Project Name	Stoughton Dam Review (EOR project 01770-0001)	Date	7/7/2022
To / Contact info	David Pfeiffer (Town of Pleasant Springs)		
Cc / Contact info			
From / Contact info	Steve Gaffield, PE; Nick Hayden, PE;		
Regarding	Review of City of Stoughton Yahara River Park project

Project Scope and Background

EOR reviewed the City of Stoughton's proposed Yahara River Park project on behalf of the Town of Pleasant Springs, to provide information about potential changes the project would create along the Yahara River in the Town. This memorandum summarizes our observations and conclusions.

Figure 3. Bathymetric data from FIS model cross section BQ in the widening upstream of CTH B. View is looking downstream with vertical exaggeration. See Figure 4 for cross section location. Water surface elevations are estimated by REP for 150 cfs for existing and proposed winter conditions.

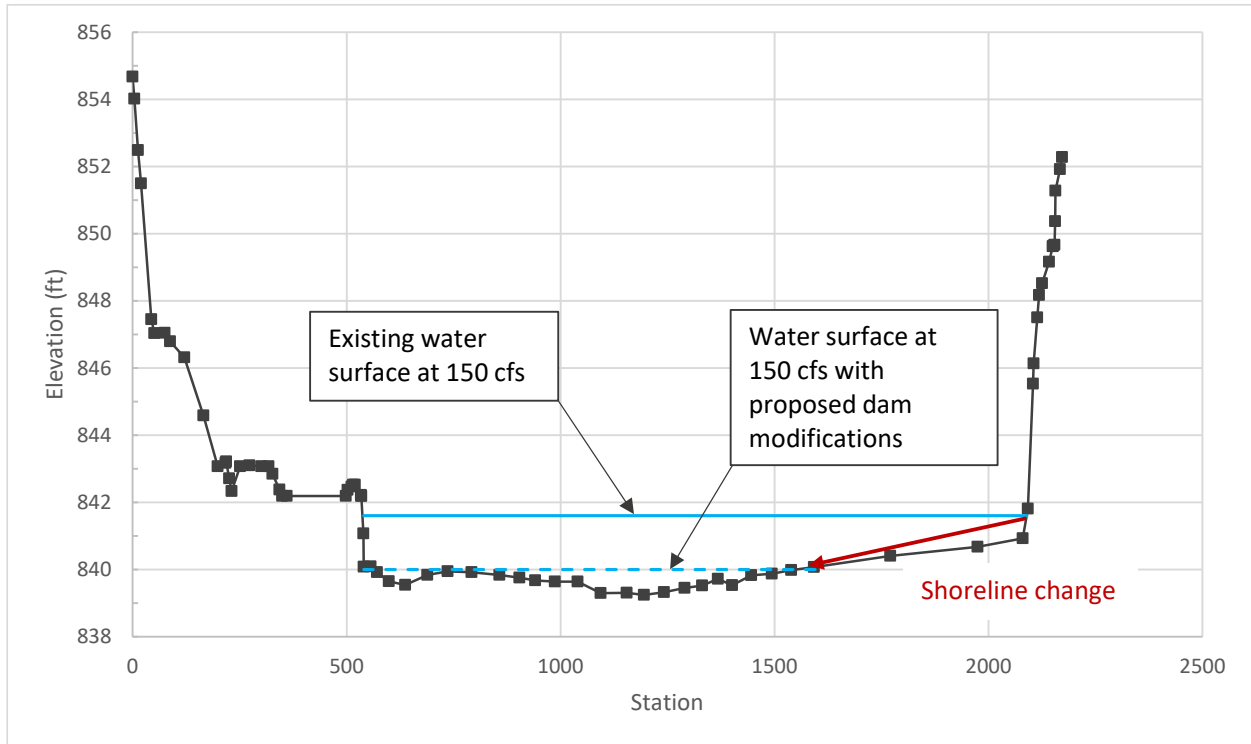
Note that the City did not collect bathymetric data of the riverbed elevation upstream of the millpond. The only available data on the riverbed elevation is in the cross sections of the 2012 Flood Insurance Study model. Model cross sections are based on 2005 LiDAR data above the water surface, with field surveyed data for the river channel below the water level at many (but not all) cross sections. The cross section in the widening upstream of CTH B (FIS cross section BQ) was surveyed (**Figures 3 and 4**), with riverbed elevations ranging from 839.24 ft to 840.93 ft. For the existing winter conditions water surface elevation of 841.6 ft at 150 cfs predicted by REP, water depths for these surveyed points would range from 2.4 ft to 0.7 ft.

The water level drop predicted by REP for the project upstream of CTH B is very large relative to the existing low-flow depth. More data is needed to accurately map potential changes in the river shoreline position in Pleasant Springs due to the proposed project, but this data was not collected during the City's design process. At FIS cross section BQ in the widening upstream of CTH B, the project would result in shoreline recession of about 500 ft at a flow of 150 cfs during November – April, based on REPs water level predictions and the bathymetric data from the FIS.

3. The change in the position of the edge of water cannot be mapped precisely due to the lack of available bathymetric data. However, the scale of the predicted water level drop is large relative to the water depth upstream of CTH B.

Figure 5. Hydraulic model profile for simulations of existing conditions, the proposed dam modifications, and the proposed dam modifications plus the proposed dredging upstream of CTH B.

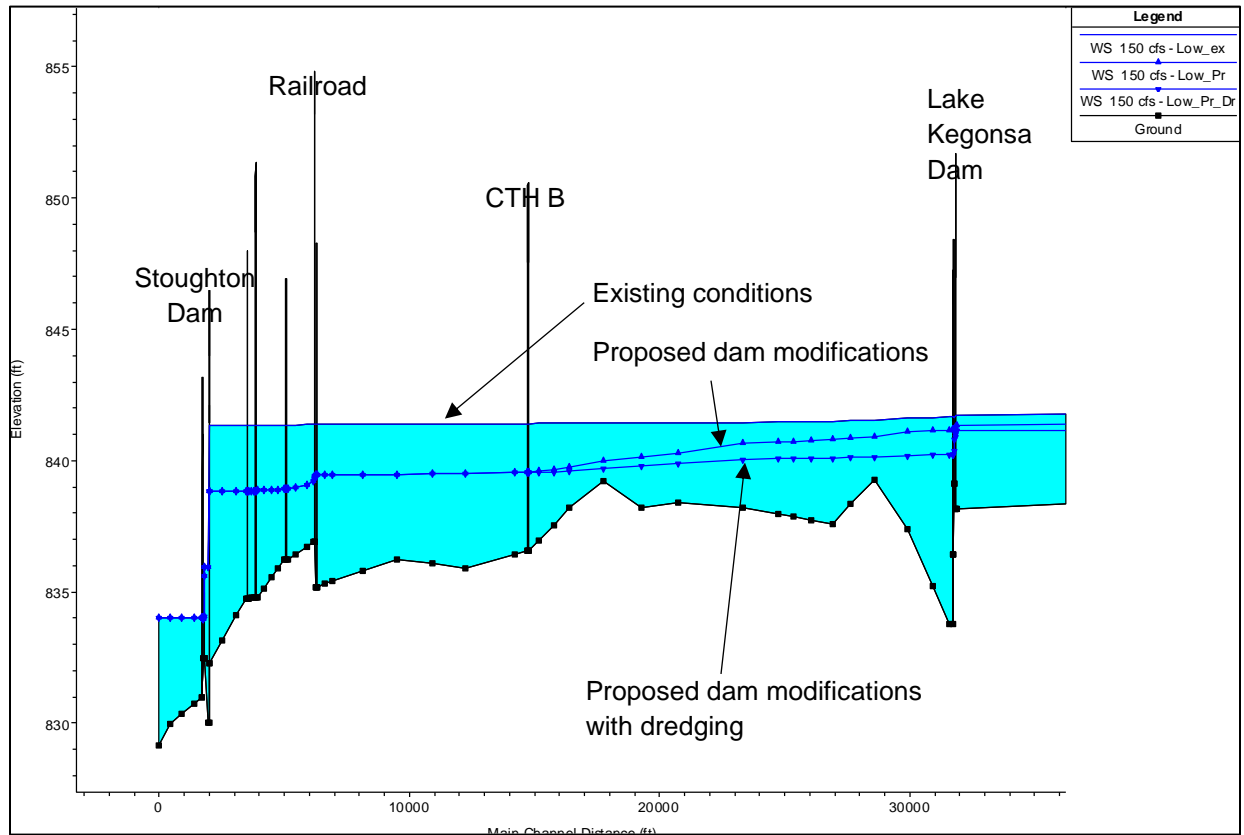
The model simulations predict that dredging upstream of CTH B would lower the water surface in addition to the drop predicted by REP for the proposed dam modifications. At a low flow of 150 cfs, this additional lowering would start at CTH B, be approximately 0.3 ft in the widening upstream of CTH B, and increase to approximately 0.9 ft near the Lake Kegonsa dam (**Figure 5**). Results were similar for both the low and high roughness simulations. Future dredging downstream of CTH B could result in additional water surface decreases in this reach.

6. Our screening analysis indicates that the proposed Dane County dredging would further lower water levels upstream of CTH B in addition to the lowering due to the proposed dam modifications. In the widening upstream of CTH B, this additional lowering would be approximately 0.3 ft. Further evaluation of the combined effects of the proposed dam modifications and dredging by the City and/or County is recommended.
